**STAFF REPORT: NOVEMBER 13, 2024 REGULAR MEETING      PREPARED BY: T. BOSCARINO**

**APPLICATION NUMBER: HDC2024-00609**

**ADDRESS: 932 EDISON**

**SCOPE: REPLACE WINDOWS (WORK STARTED WITHOUT APPROVAL), DOORS, REAR PORCH, AND SIDING, INSTALL POOL**

*August 29, 2022, staff photo showing window removal.*

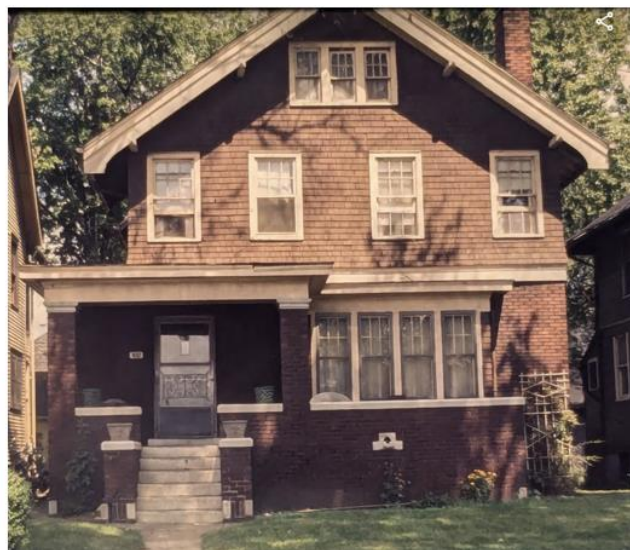
In 2022, staff observed three windows missing from the front façade, second story. This work was not approved by the Historic District Commission.

- The three windows already removed without approval, and the existing windows proposed for replacement, are unambiguously character-defining as they are subdivided, as described in the Elements of Design, adding textural interest to the façade and serving as a prominent visual component of the building. Further, their six-over-one muntin pattern is consistent with the Arts and Crafts style of the building and is important to the overall character of the building and the district.

- The application materials appear to largely depict the missing windows, with few photos of the windows that remain. From the street, the existing windows appear, to staff, to be damaged but not beyond repair.

*Proposed door. Image from application.*

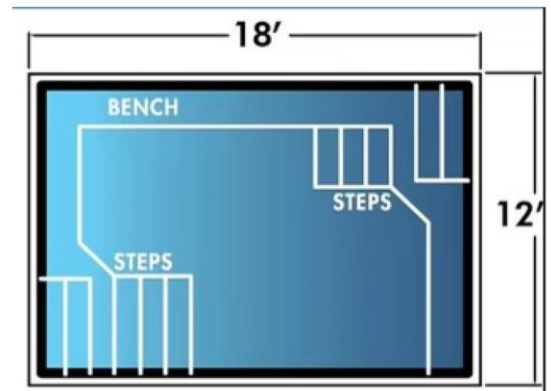
The applicant proposes to replace three exterior doors. Though the application does not provide exact specifications, the image provided depicts a Feather River molded fiberglass door with “chestnut mahogany” woodgrain appearance.

- The side door appears to be a historic and character-defining feature, in staff opinion. It has not been shown to be beyond repair.
- The rear door is not visible in application photos as it is concealed behind a screen door.

- Specifications for proposed doors are not provided.
- ~~Pool installation frequently includes site work such as walkways or retaining walls, but this is not shown in the application.~~

- The side door is a historic feature that has not been shown to be deteriorated beyond repair; a photo of the rear door has not been provided.

- The siding shall consist of wood shakes, subject to staff approval.
- The final siding installation shall be subject to staff approval.
- The new rear porch shall be made of wood and closely match the dimensions and appearance of the existing porch, subject to staff review.
- The new front door shall be subject to staff approval.
- ~~Any site work associated with the pool shall be subject to staff review.~~
